Project Address 4175 Iron Gate Road Zip Code 98226
Tax Assessor Parcel Number (s) 3803083362100000
Project Description The project includes construction of a new 94-lot subdivision with associated access roads and utility infrastructure.

Subject: Response to Request for Information  
Queen Mountain Plat – 4175 Irongate Road

Permit(s): SUB2022-0021; VAR2022-0007; CAP2022-0018, SEP2022-0024

SHEET CONTENTS:  
**OVERALL UTILITY PLAN**

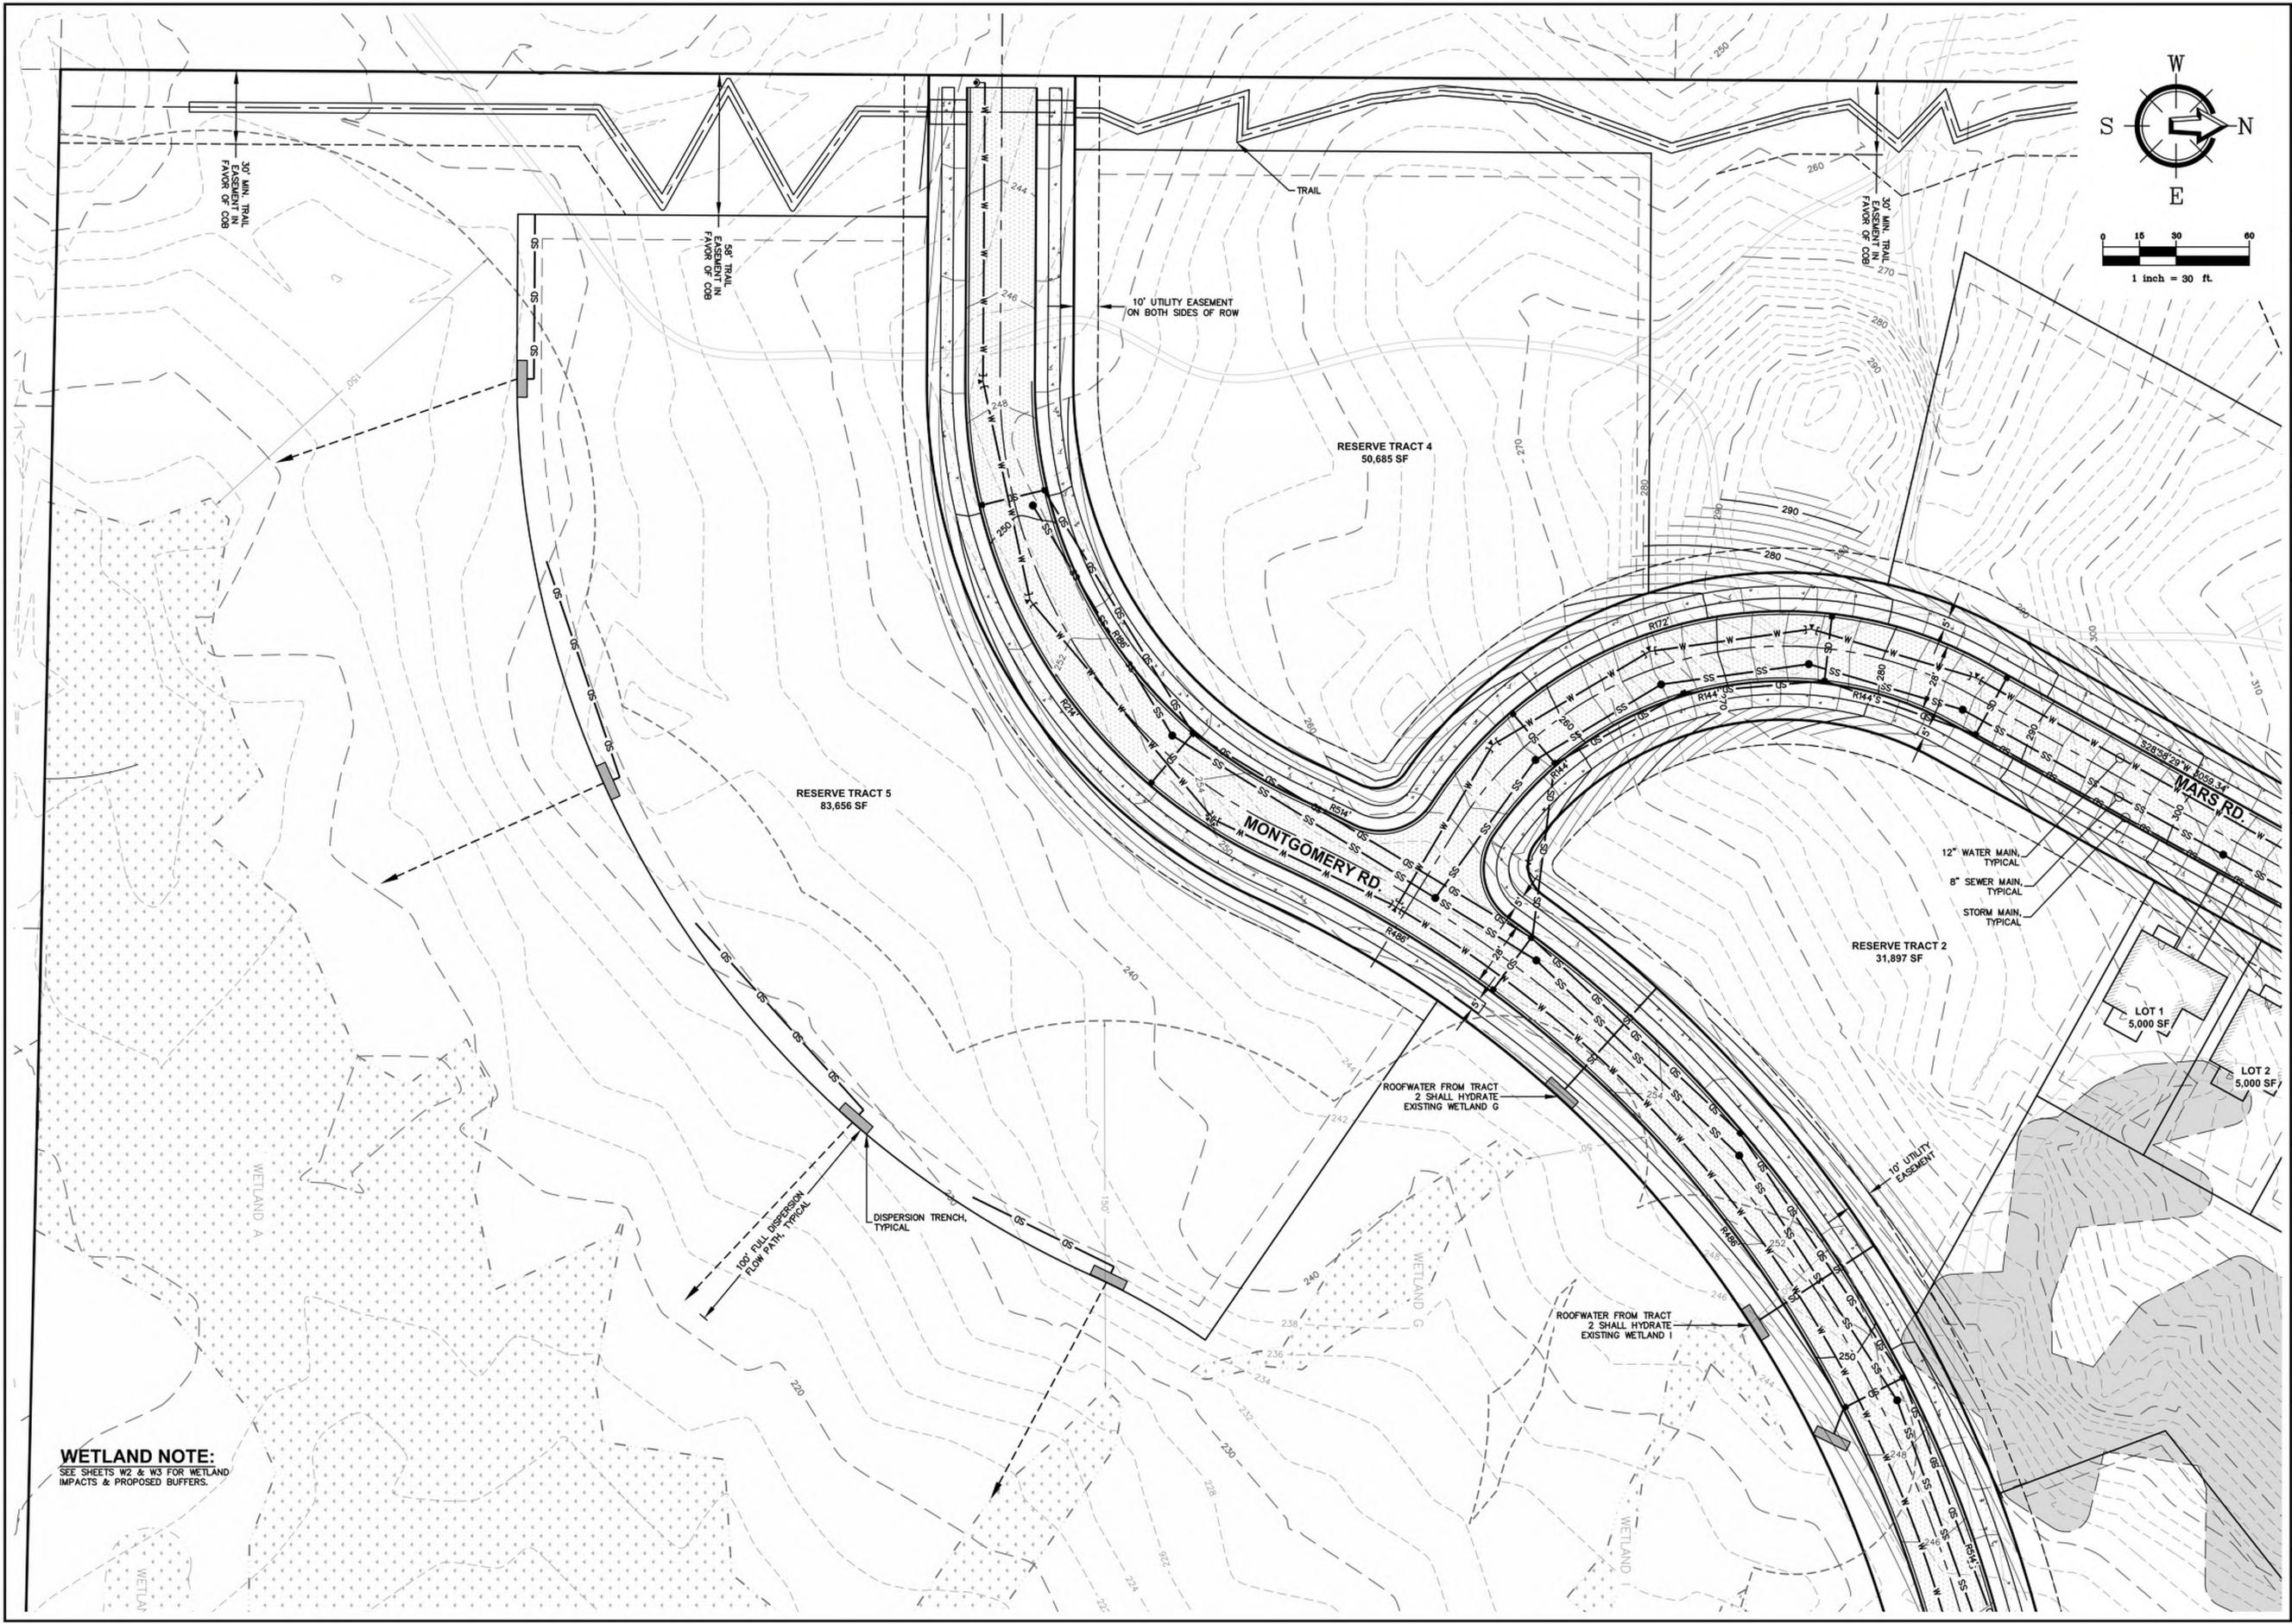
**ACTION ITEM:** Please include a utility overview plan.

**Response: Utility Overview now included.**

SHEET CONTENTS:  
**IRON GATE ROAD PROFILE**  
 0+00 - 8+24

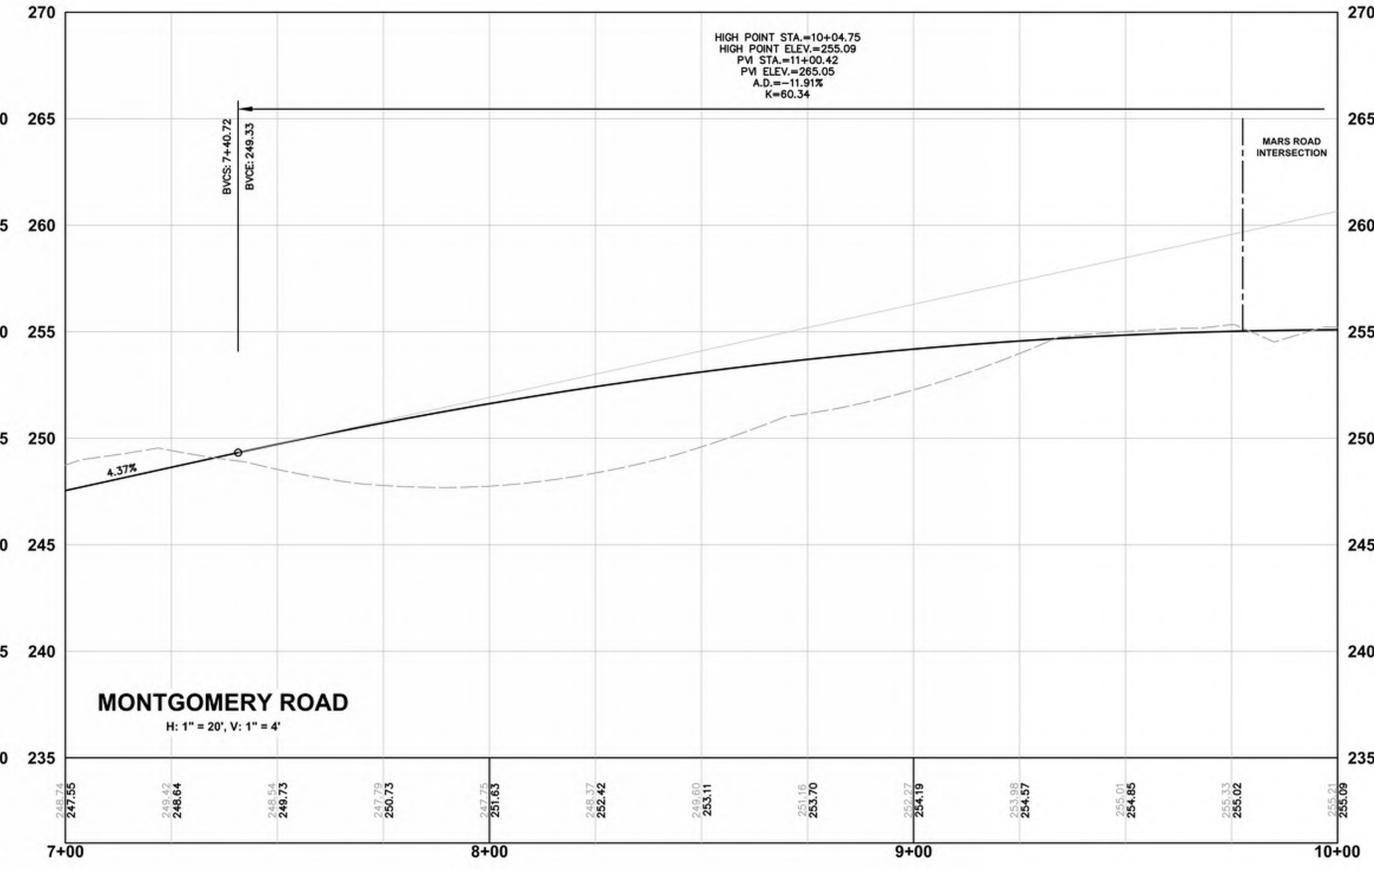
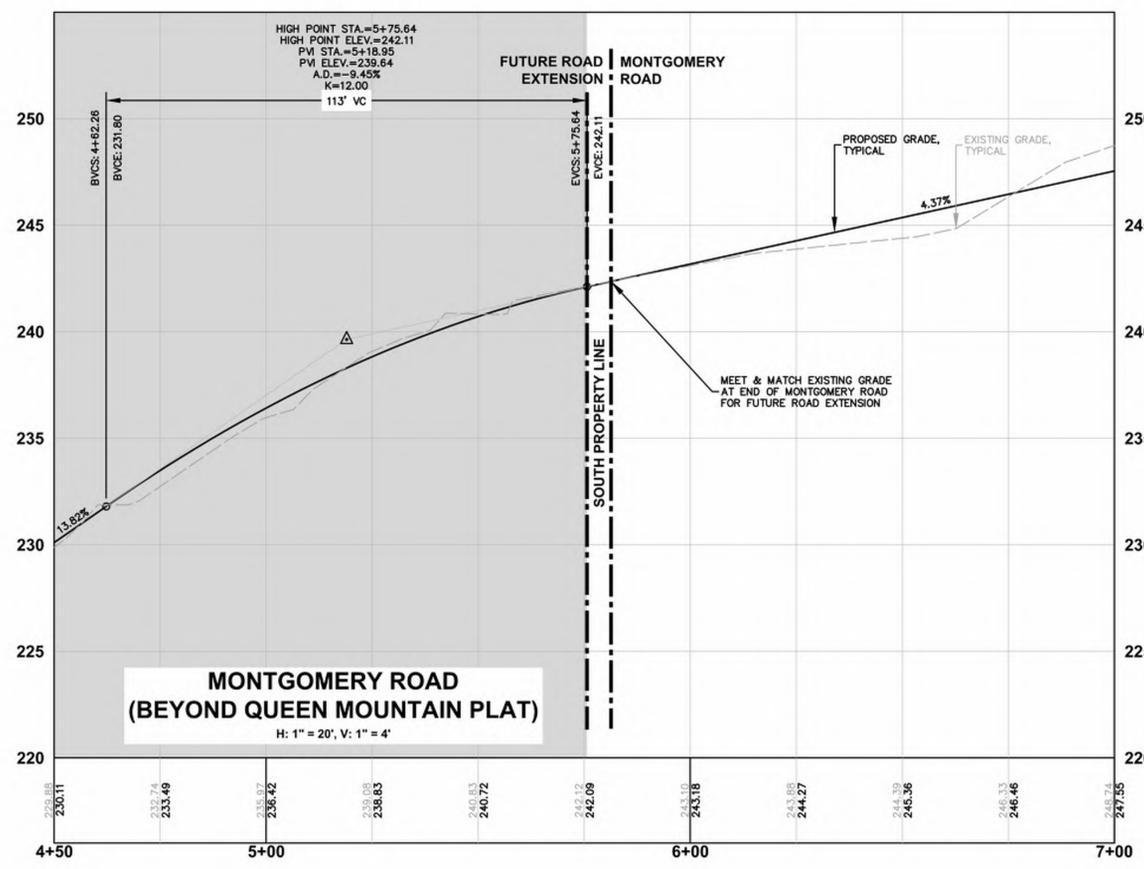
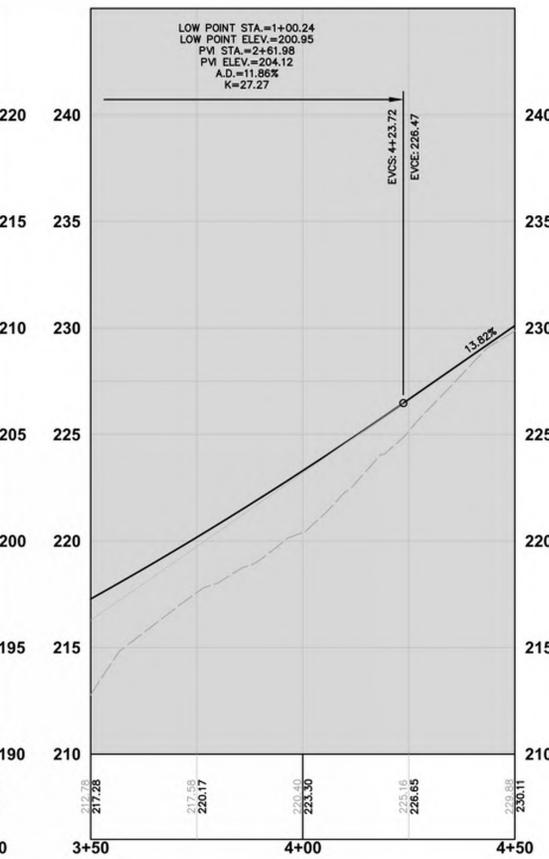
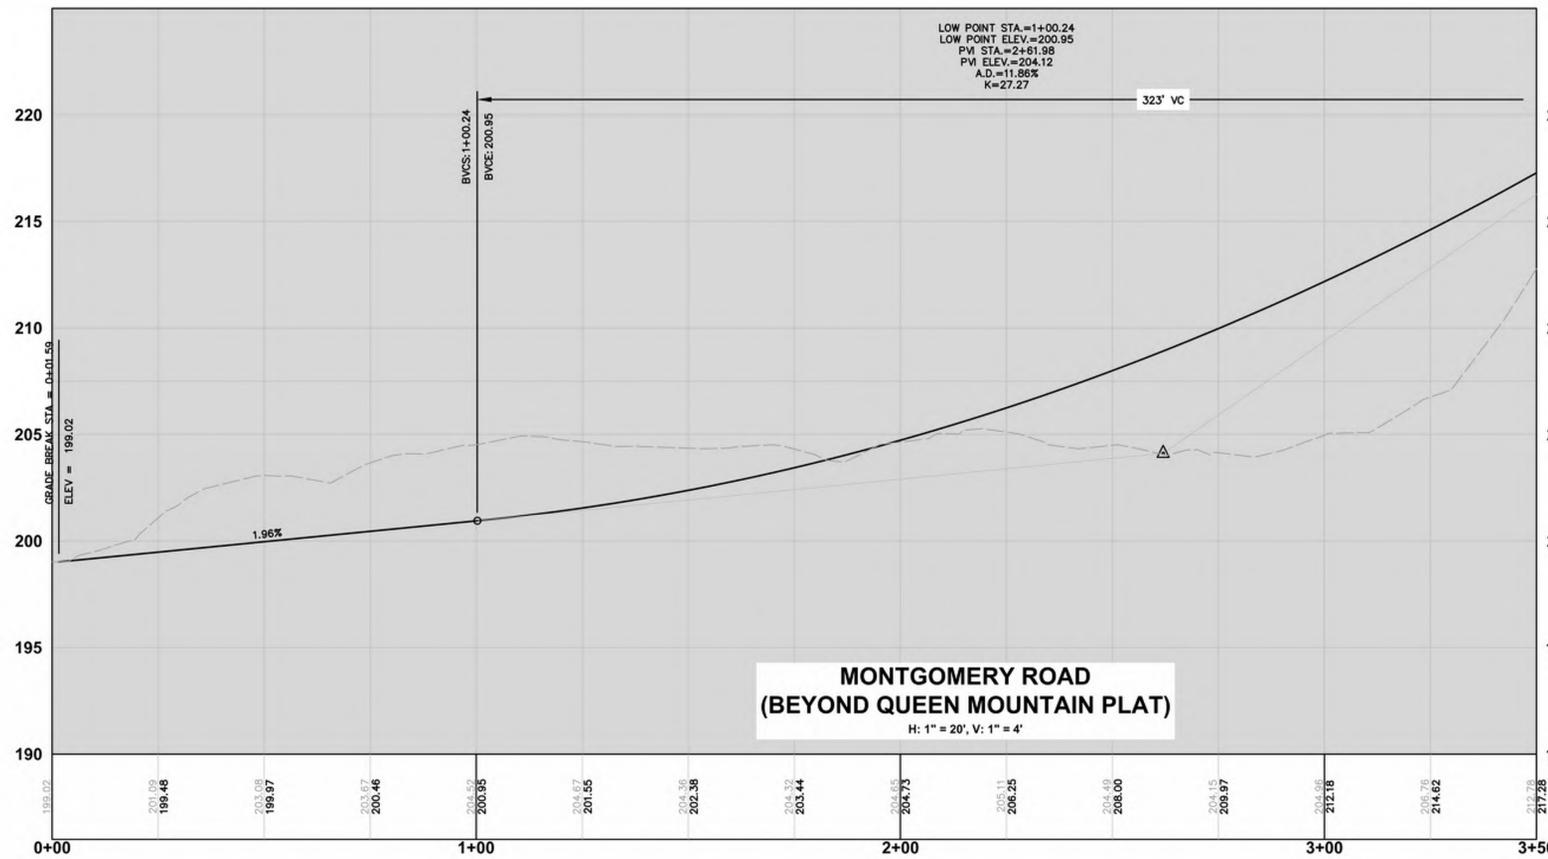
**ACTION ITEM:** Revise the application materials to provide a response consistent with the applicable decision criteria for the specific street connections identified above. The plat layout shall be amended as necessary to provide these street connections and or demonstrate how this proposal is providing its proportionate orderly extension.

**Response: Road A (now Richard Street) has been realigned to allow for connection north and east. More detailed road profile information has been added for a future extension of Montgomery Road. The Montgomery Road alignment at the west property line has been moved south after further study of the existing grades to the west. The proposed alignment allows the road to be constructed to the property line and avoids rock outcroppings and steep ridges along the future alignment. See study included with submittal.**
